UNITED STATES PATENT AND TRADEMARK OFFICE

APPLICATION NO.	FILING DATE	FIRST NAMED INVENTOR	ATTORNEY DOCKET NO.	CONFIRMATION NO.
10/661,847	09/12/2003	Charles Edward Boardman	24-AT-135243	8534
7590 10/16/2008				
Patrick W. Rasche Armstrong Teasdale LLP Suite 2600 One Metropolitan Square St. Louis, MO 63102			EXAMINER GREENE, DANIEL LAWSON	
			ART UNIT 3694	PAPER NUMBER
			MAIL DATE 10/16/2008	DELIVERY MODE PAPER

Office Action Summary

DETAILED ACTION

FIG. 1

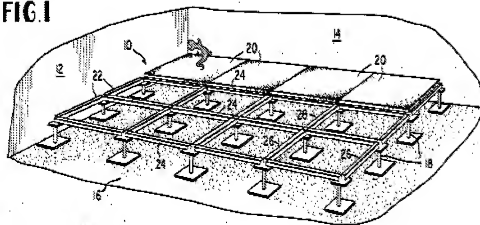
This type of separation of parts appears to most directly reflect a modification from the secondary references by placing the groove around the outside edge of each individual segment (support block) to engage the underlying support grid, much like a ceiling or floor tile such as from Bettingers Figures 1 and 2.

FIG. 3

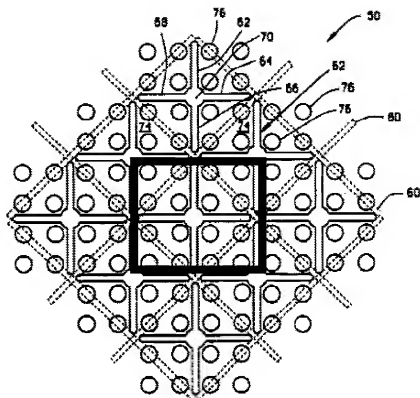
However, it is noted that applicant did not separate the integral support plate in the same manner, instead, applicant separated the plate along a different line as illustrated immediately below:

The separation of the integral support plate in to multiple individual support plates in this manner would clearly be well within one of ordinary skill in the art because the end result is the same, i.e. the integral plate has been subdivided into smaller units but together they still support the same function as the integral plate itself, i.e. support the reactor fuel assemblies.

As one can see, the separation into individual squares is a design choice as to the direction of the squares (or other examples of arrangements (hexagons, etc.)
